**OFFICIAL COORDINATION REQUEST FOR
NON-ROUTINE OPERATIONS AND MAINTENANCE**

COORDINATION TITLE- 17BON03 Cascade Island Entrance Pool Repairs

PROJECT- Bonneville

Figure 1. Overhead view of the Cascades Island Entrance Bay and impacted areas.

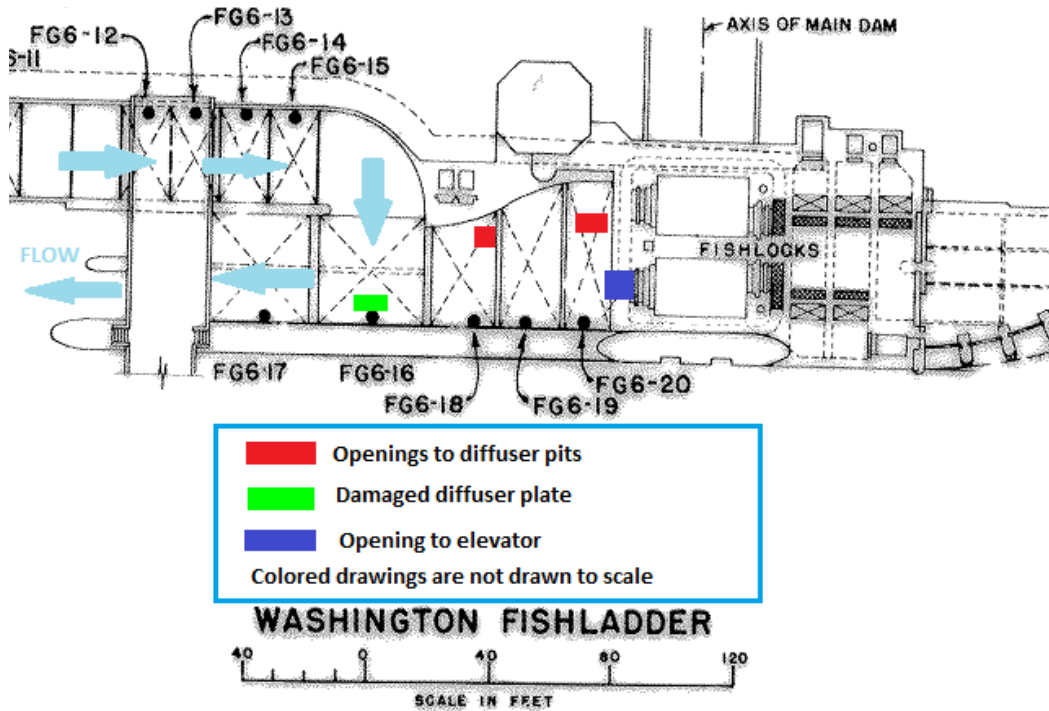
1. A diffuser pit access hatch across from FG6-18 is displaced, leaving an opening into the diffuser pit.
2. A piece of grating at FG6-20 is blown off, leaving an opening into the diffuser pit.
3. One of two channel keeper bars on the FG6-16 diffuser plate is blown off. These bars hold the diffuser plate in place. When the other bar goes, the diffuser plate will displace leaving an opening to the diffuser pit below.
4. The south elevator door has a screened opening at its base that is blown open.

Taking a look at the MOC and following the gary email saga I will stick with my original recommendation that we should just plan on getting the work done this year, especially since CI is not going down next year, 2 years might be a little too long to wait on this stuff, and it would be good to get some eyeballs on these areas to determine their overall condition incase we need to be prepared to do more extensive work in 2 years.

Thanks for the response Andrew. I certainly wouldn't want to see this issue go two years, so I guess I'm still in the camp of getting this work done as soon as you guys can.

Erin, As far as I am concerned, these fishway systems are critical and need to be kept in good shape. It seems to me that having all these failures in the CI system in one season is indicative of a pretty rickety system. So, while no action may be a viable option, I think it risks more damage and possibly losing some fish. Fixing the damage is low risk and I recommend getting it done as indicated in early March. I appreciate the time someone took to put together the detailed analysis of impacts. Do you have a itemized breakdown of that \$30-35K cost estimate? Thanks, Gary

1. No action. Wait until the next scheduled dewatering of the ladder during winter of 2018/19 to make the fixes. This entails leaving diffusers FG6-18, FG6-19 and FG6-20 closed, and reprogramming the system to use other diffusers to adjust. The project believes this is a viable option and that ladder criteria could be maintained with minimal impact.
2. Dewater and fix in early March. This would entail a full dewatering of the CI ladder and Entrance Bay for a week of work, with an estimated cost of ~\$30,000-35,000.

1. No outage.
2. Fixing in March would require dewatering the CI ladder and entrance for four days (06 – 09 March).
